Report to
Energy Consumers Australia

Advice on the Capex Portion of the AER's Revenue Determination for TransGrid

2 January 2018

Figure 1: AusGrid's Historic Base Forecast for Inner Sydney

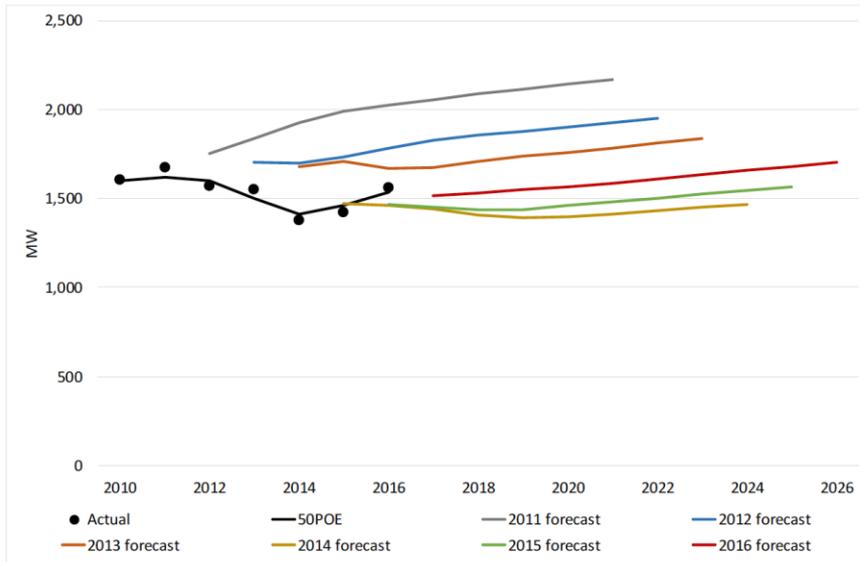
The GHD report attached to the TransGrid proposal has two charts that show the past performance of the AusGrid forecasts for inner Sydney, Figure 1, and the makeup of the AusGrid 2016 development forecast, Figure 2. The first figure shows the base forecasts and not development forecasts. It shows that the forecasts prior to 2014 were similar to other forecasters over this period, perhaps even worse than some, and then they were improved significantly. These forecasts would appear reasonable.

Figure 2: AusGrid's 2016 Developmental Forecast and Constituent Parts

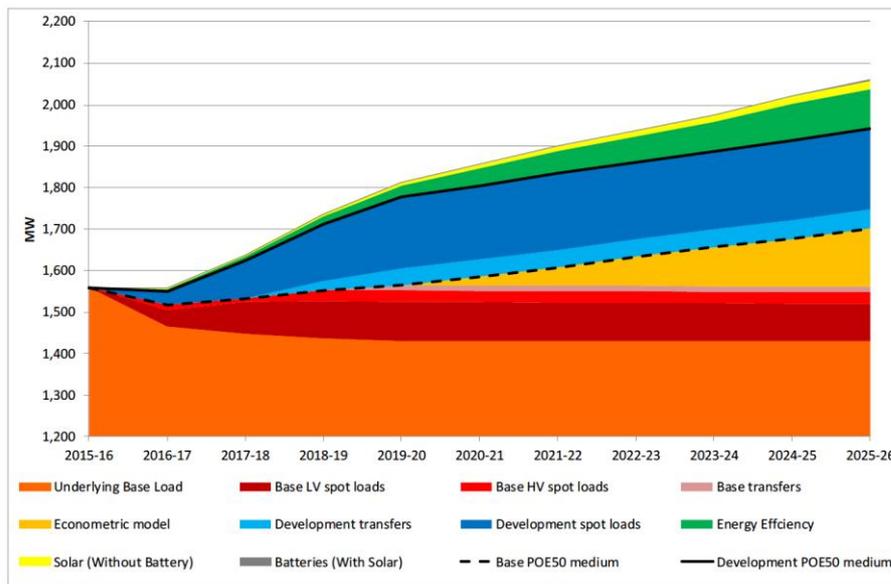
However, it is the development forecast in Figure 2 which has been used in the regulatory Investment Test for Transmission (RIT-T) for PSF. There is a 200MW increase over the base forecast by 2019/20 which is massive; effectively a 6.5% annual growth rate. Most of the new buildings have a 5 star NABERS rating compared to the old stock which would be 2 or 3 star rated and the estimated reduction in energy cost going from a 2 star building to a 5 star building is about 55%⁸. This would imply that there is significant growth, well in excess of the already high 6.5% in order to get the demand change predicted.

Figure 3: City of Sydney: GHG Emissions Past and Forecast⁹

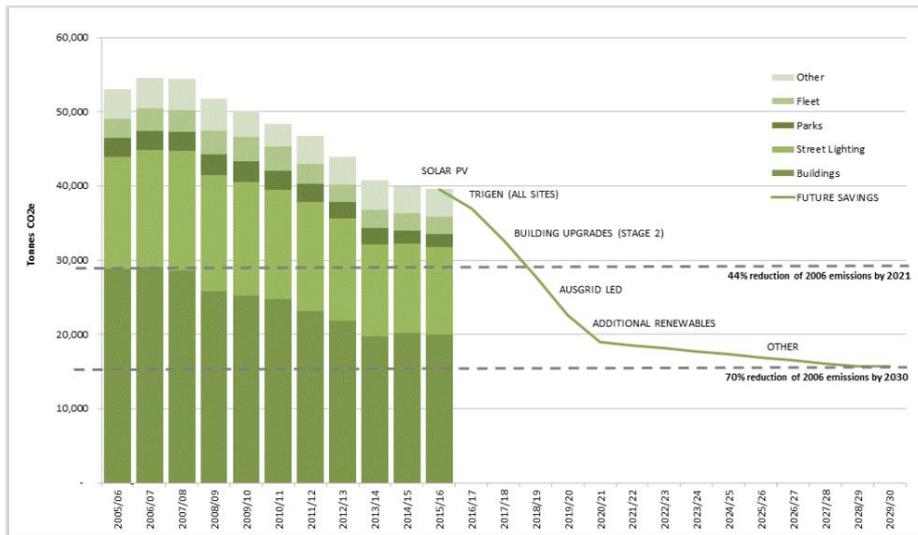
There is a significant change occurring in high rise building energy efficiency around the country at present in terms of building design and retro-fitting of trigeneration and other measures. For example, the City of Sydney established the Sustainable Sydney 2030 program in 2008 and one of the targets was to reduce the Green House Gas (GHG) emissions by 70% by 2030 in the City of Sydney. A large part of that reduction is to come from projects such as the mandatory NABERS ratings of all commercial building and the promotion of trigeneration for upgrading the efficiency of buildings. Figure 1 shows the past and forecast GHG emissions taken from the statutory GHG reporting and future programs. It can be seen that a 26% reduction has already been achieved and further programs are forecast to cut the levels further. The results achieved so far are with a background of growth in the Sydney CBD and surrounds. This does not appear to be adequately factored into the demand forecasts of AusGrid.
